**MORRISON-KNUDSEN ENGINEERS, INC.**

**UMTRA PROJECT**

4005-GEN-L-01-00944-00

Review Comments on 4/4/85 - 5/7/85 Draft of "Methodology for  
Evaluating Long Term Stabilization Designs of Uranium Mill  
Tailings Impoundments", CSU Report to NRC

Figure 35. Event Tree for Failure Modes Identified by Nelson, et al (1984)

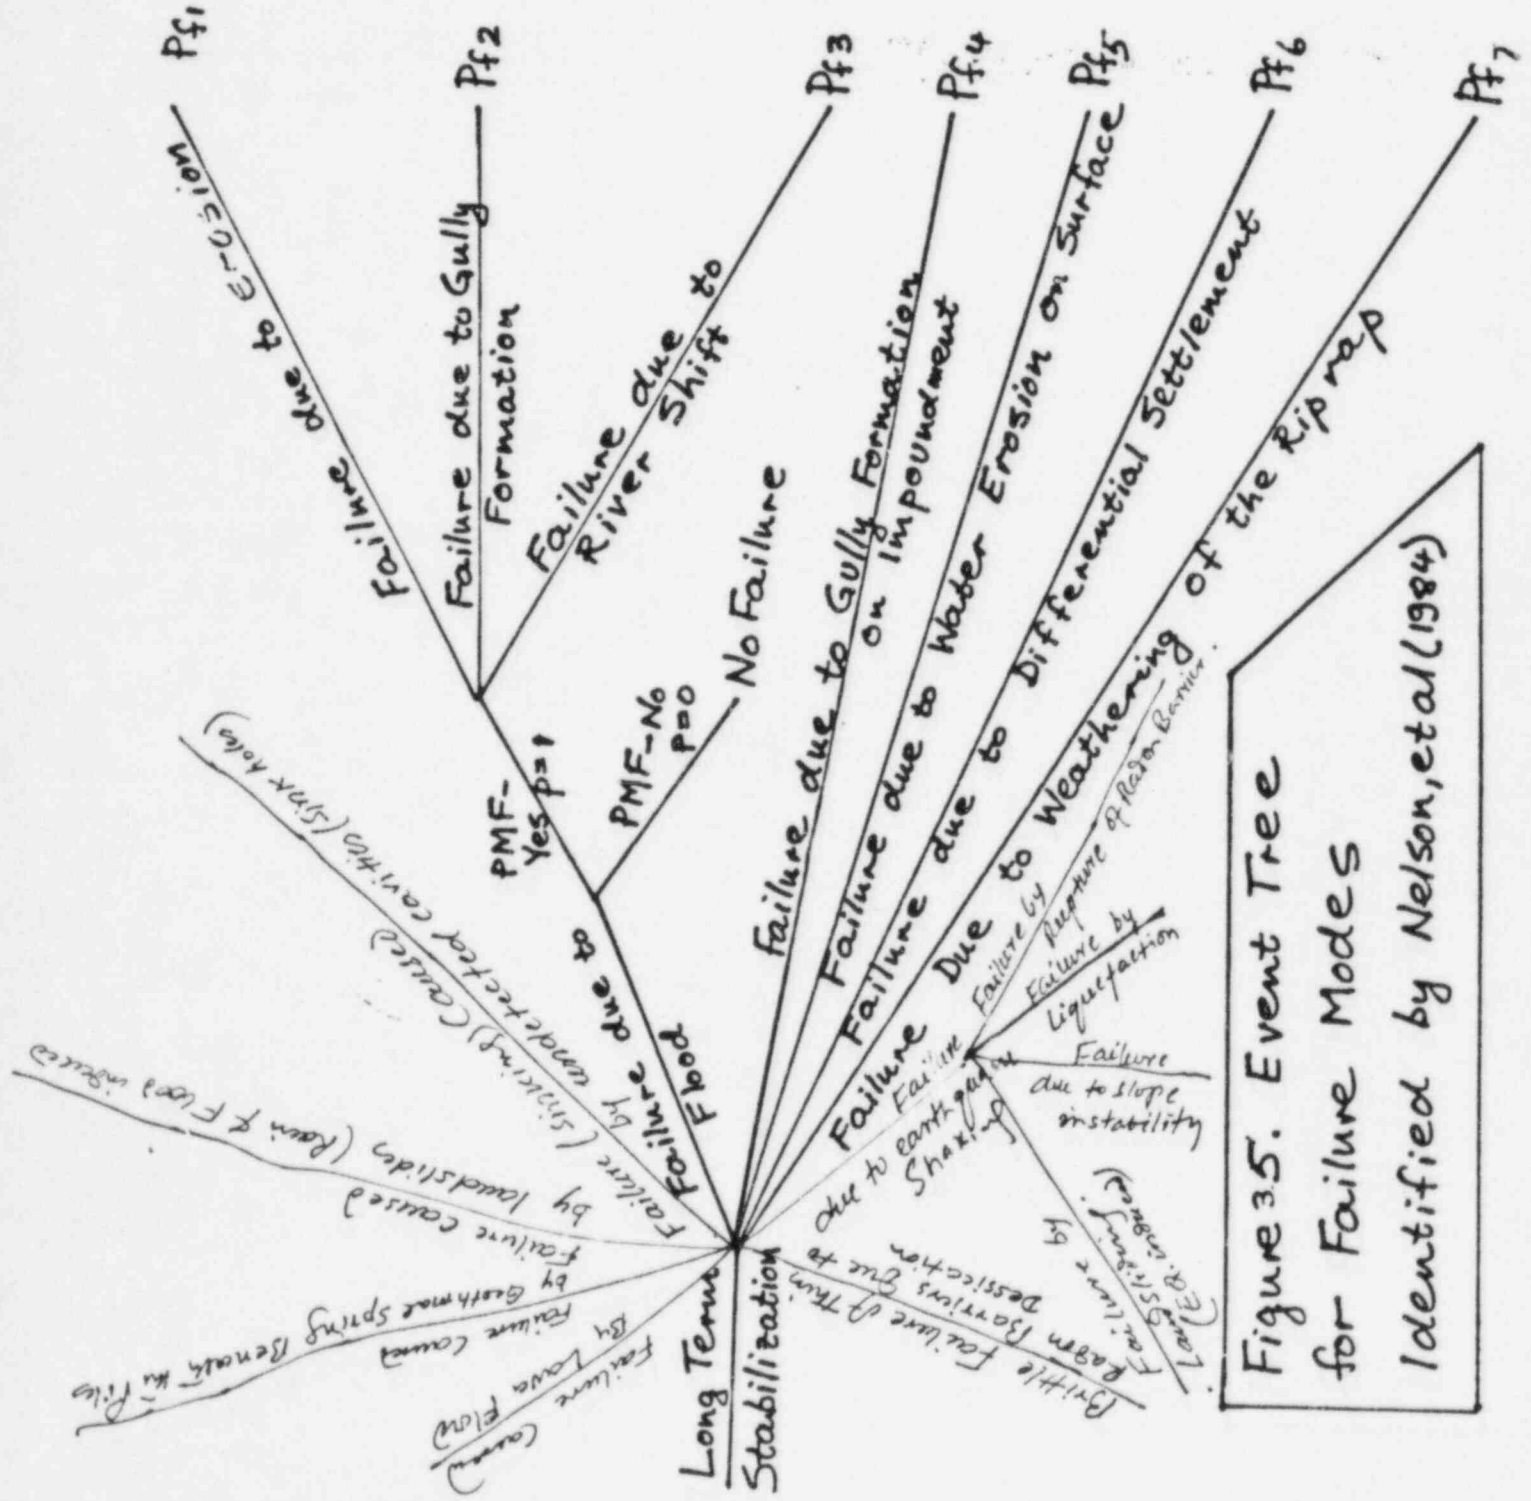
What is this?

Must consider all modes  
of failure adopting  
systems approach.

Fig. 3.7 Channel classification showing relative stability and types of hazards encountered with each pattern.

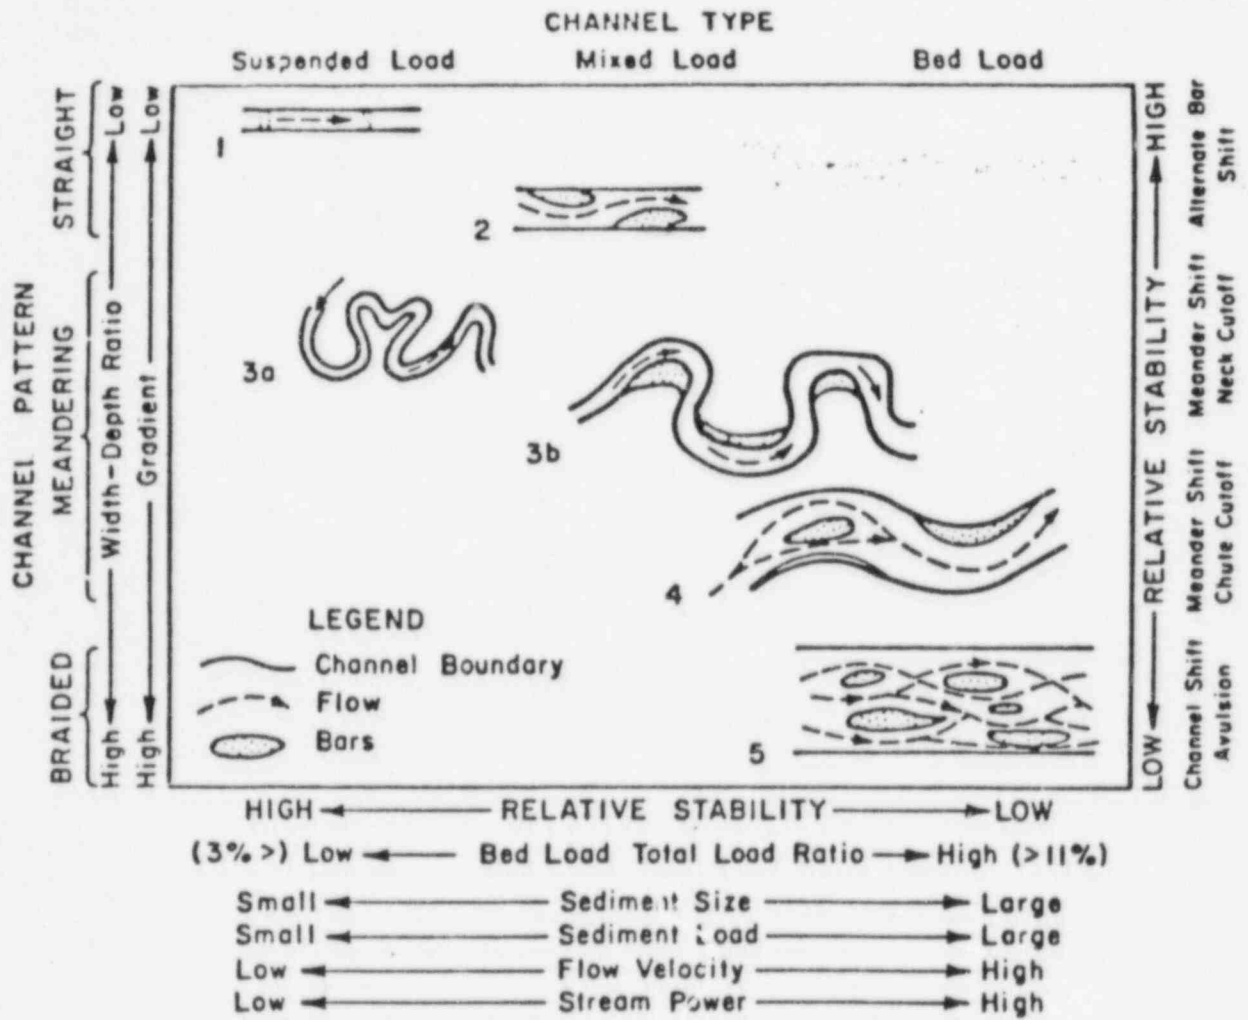
*Please Cite Reference 2*

Fig. 5.1 Title? Ref.?

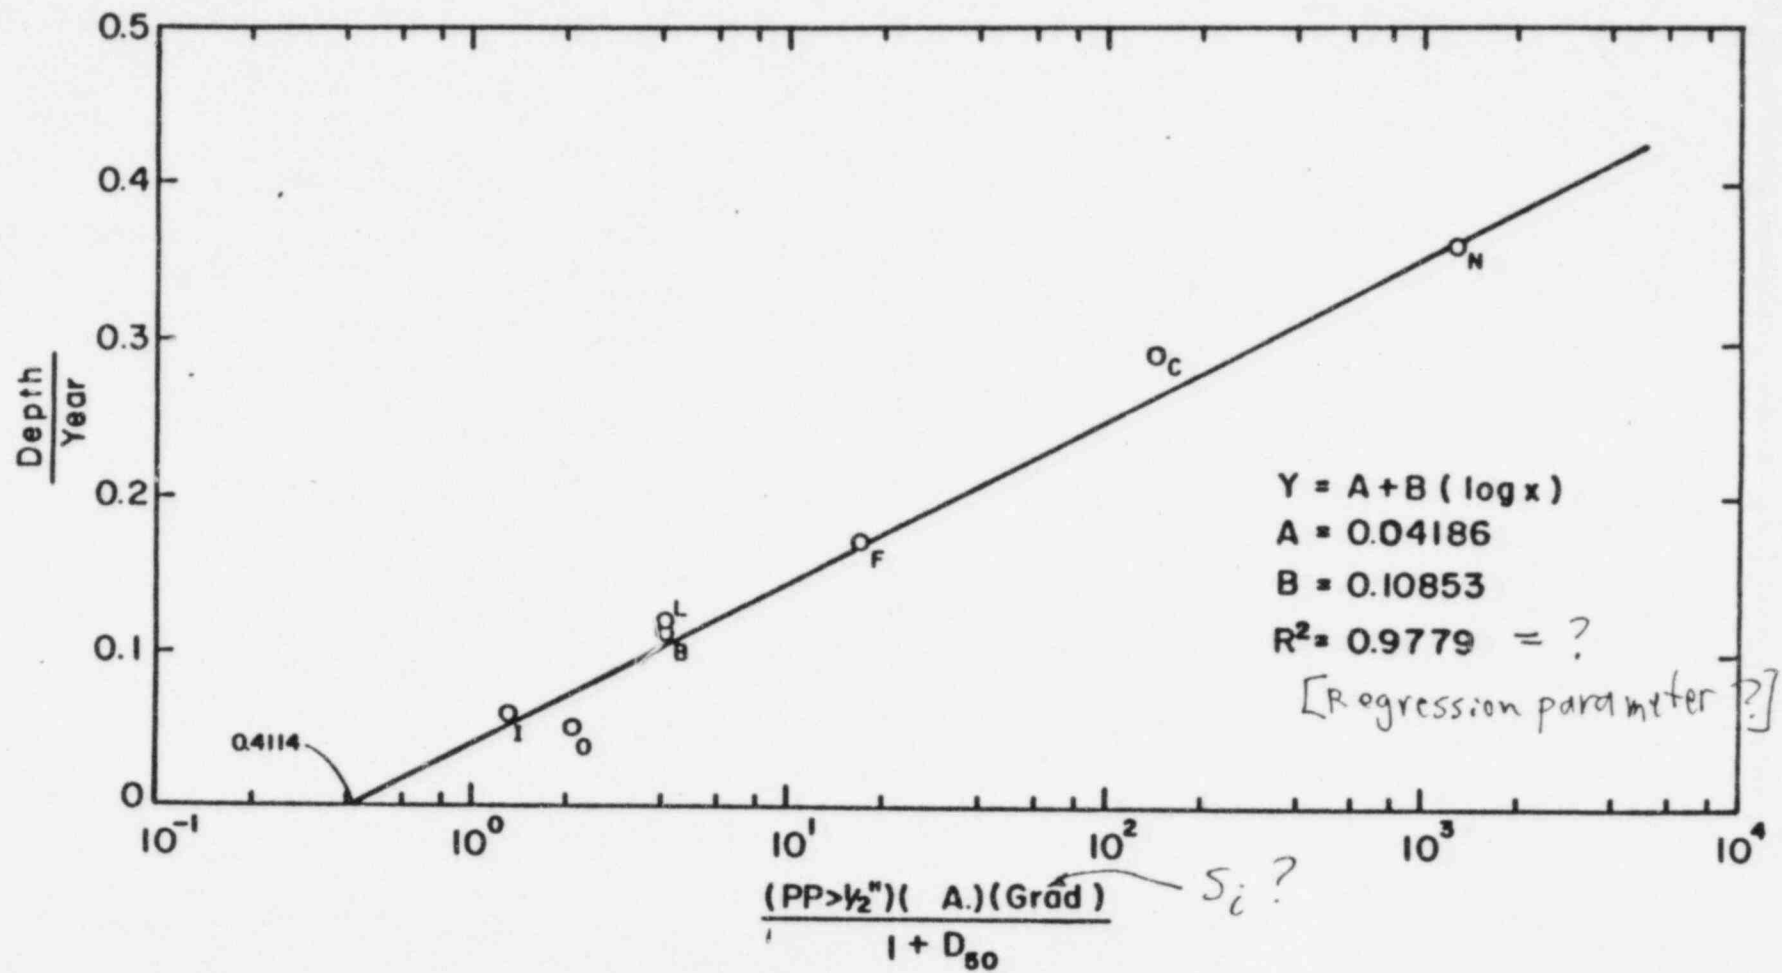
(303) 482-0583 Nisley & Schumm Ref.

Fig. 5.9 Curve to Determine Maximum Stone Size in Riprap Mixture

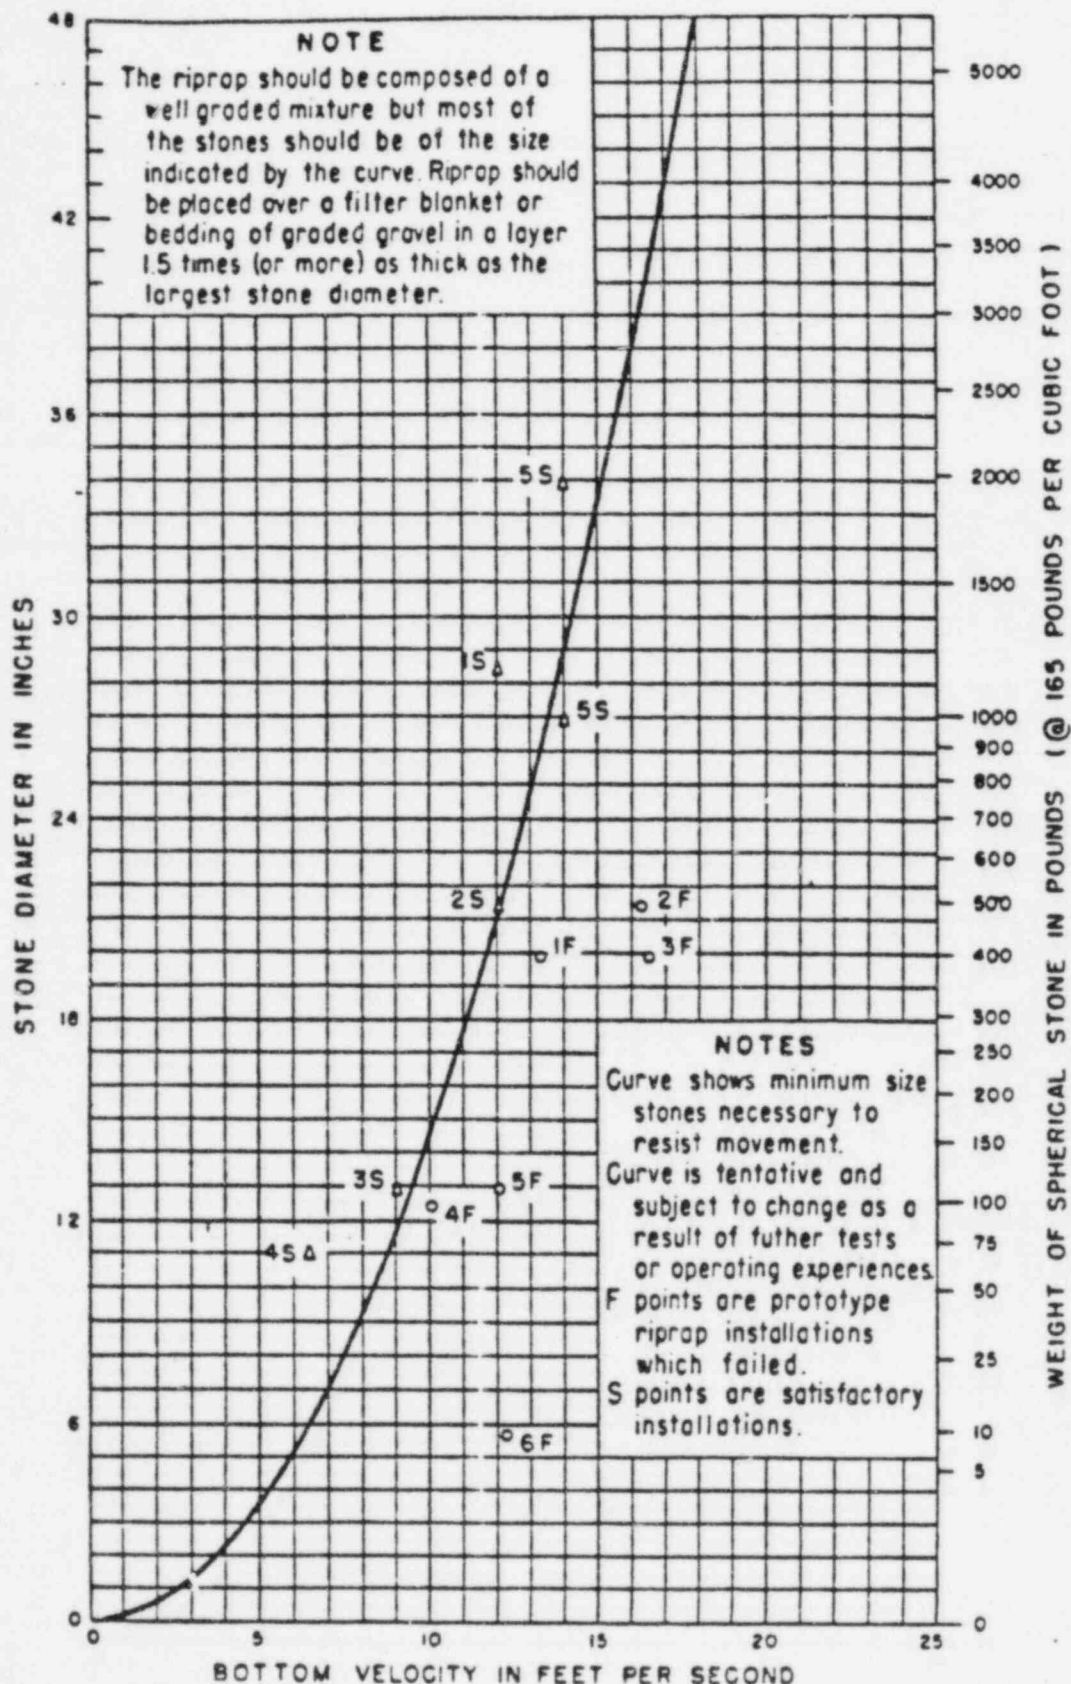
(Ref. ?)
